# UNITED STATES PATENT AND TRADEMARK OFFICE

APPLICATION NO.	FILING DATE	FIRST NAMED INVENTOR	ATTORNEY DOCKET NO.	CONFIRMATION NO.
09/460,552	12/14/1999	DAVID L. DEAN, JR.	HE0083	2615

# Office Action Summary

## DETAILED ACTION

FIG. 4

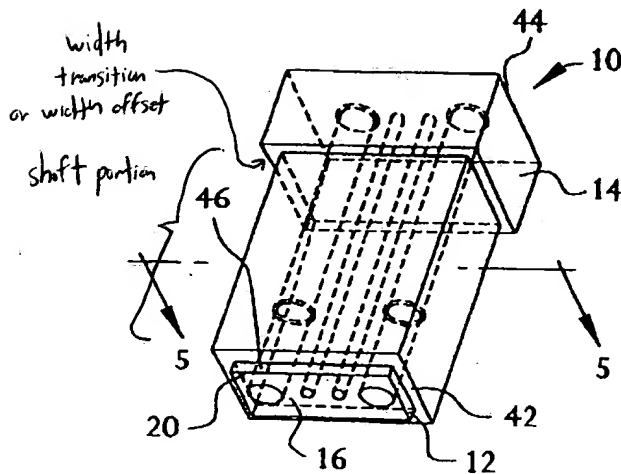
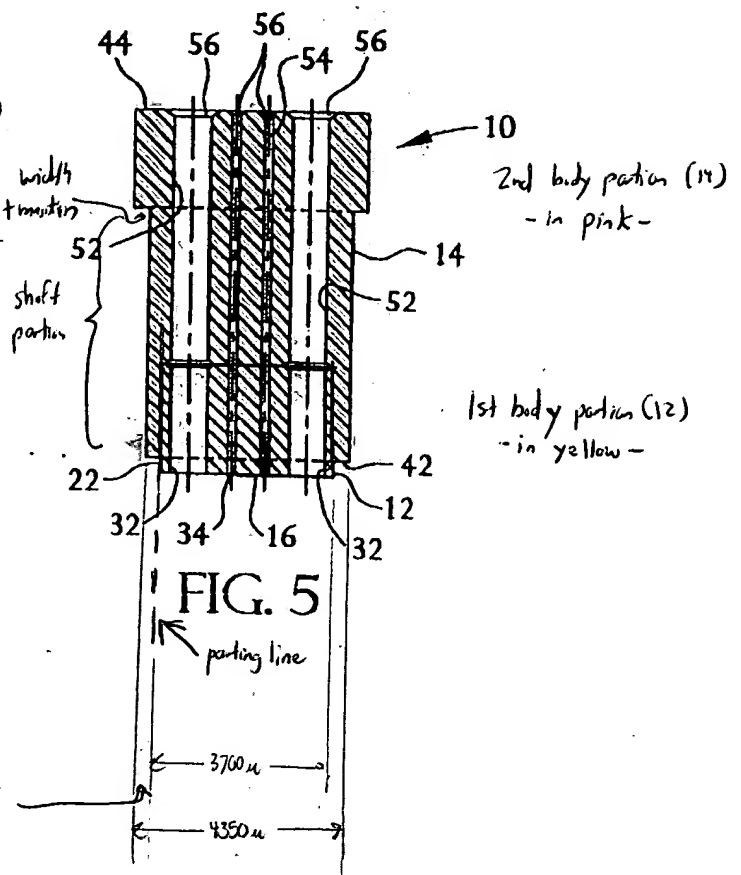
In regard to claim 1, Edwards et al. discloses (see Figures 4 and 5) a ferrule comprising at least one optical fiber bore (34) associated with a front surface (42) and a rear surface (44) of said ferrule as shown in Figures 4 and 5; first and second body portions (12, 14) extending at least partially between said surfaces as shown in Figures 4 and 5 and having respective widths as described in column 5, lines 60-61 and column 6, lines 53-56, a juncture of said body portions comprising an interface in the form of a parting line (i.e., where two body portions join) as shown in the lower portions of Figures

4 and 5, said parting line and said optical fiber bore extending longitudinally at least partially between said front surface and said rear surface as shown in the lower ends of Figures 4 and 5, and said parting line defining an offset of at least about 50 microns between first and second body portions as described in column 5, lines 60-61 and column 6, lines 53-56.

Regarding claim 5, Edwards et al. discloses that said parting line comprising a ledge as shown in lower portions of Figures 4 and 5.

Regarding claim 6, Edwards et al. discloses (see Figure 5) that said ferrule comprising multiple bores (34, 54) and defining a multifiber ferrule as shown in Figures 4 and 5.

In regard to claim 18, Edwards et al. discloses (see Figures 4 and 5) a ferrule comprising at least one optical fiber bore (34) extending from a front surface (42) to a rear surface (44) of said ferrule as shown in Figures 4 and 5; a shaft portion defining exterior surfaces of said ferrule as shown in Figure 4, said exterior surfaces at least partially extending longitudinally between said front and rear surfaces as shown in Figure 4; and a width transition, said width transition extending longitudinally along a portion (see lower portion of Figures 4 and 5), said ferrule shaft portion, said width transition comprising a width offset as shown in lower portion of Figures 4 and 5.

In response to this argument, the Examiner would like to point out that the limitation "a parting line" is not an actual physical structure of the ferrule but is a geometrical or virtual construct in order to describe the relationship between the first and second body portions. In a similar fashion, given the broadest reasonable interpretation, the ferrule of Edwards et al can plausibly read on the current claim language. If one examines, Figures 4 and 5 of Edwards et al, it is possible to interpret the juncture of the two body portions (12 and 14) comprising an interface in the form of a parting line, wherein said parting line and said optical fiber bore extend longitudinally at least partially between front surface and rear surface and that said parting line defines an offset of at least 50 microns between said first and second body portions (see Edwards et al., column 5, lines 60-62 and column 6, lines 53-56 for dimensions). In order to illustrate this reading based upon the current claim limitations, the Examiner has attached an annotated version of sheet 1 of 4 of US 5,926,596 showing how the limitations read on Figures 4 and 5.

In response to this argument, the Examiner refers the Applicant to the response above and to annotated version of sheet 1 of 4 of US 5,926,596 showing how the claim limitations of the shaft portion, width transition and width offset read on Figures 4 and 5.
